**2006 Mercedes Benz Truck ML 500 (164.175) V8-5.0L (113.964)**

Stop / Tail Light not Illuminating with DTCs 9102, 9103, 9106, 9107, 9126, 9127 or 9136

Topic number LI82.10-P-045622

Reason for change Cable Tie part number included

Figures 1, 2 and 3

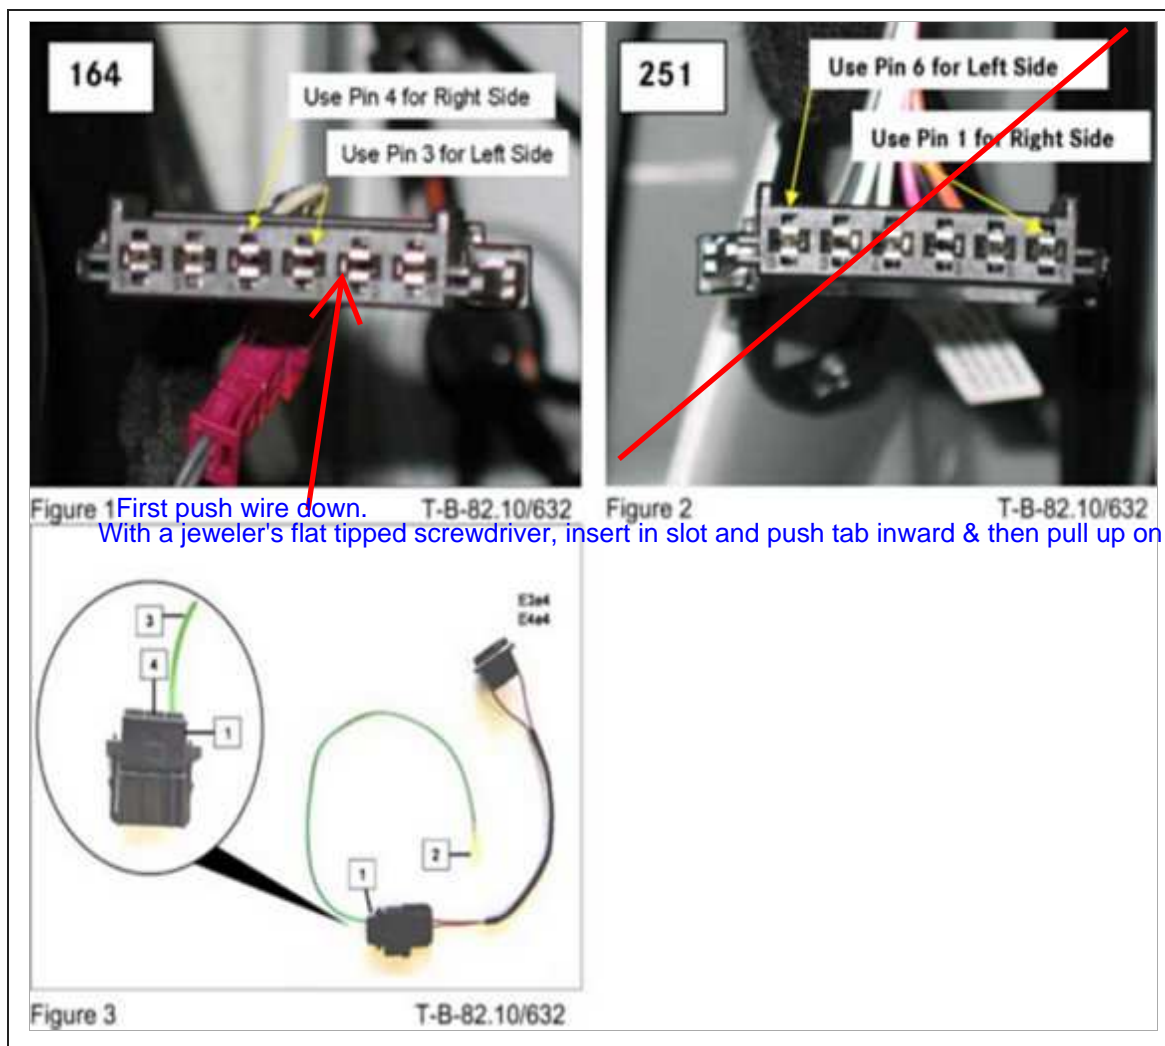
4. Remove the pin from the actuation line connector for the stop light (Figure 1 or Figure 2).

Figures 4 and 5

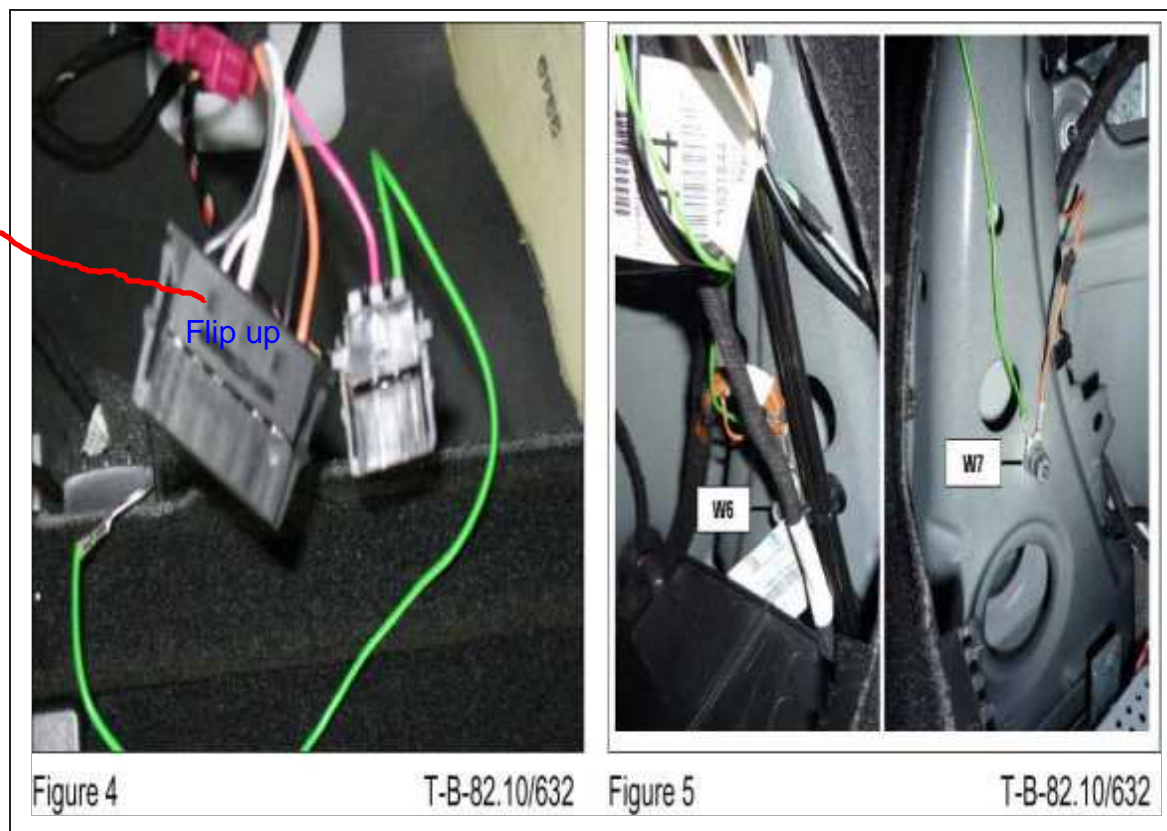
6. Insert actuation line for stop light into repair harness connector pin 2 (Figure 3, 4) and (Figure 4).

8. Attach repair harness to left wheel arch trunk line ground terminal W6, and right trunk line ground terminal W7 (Figure 5).
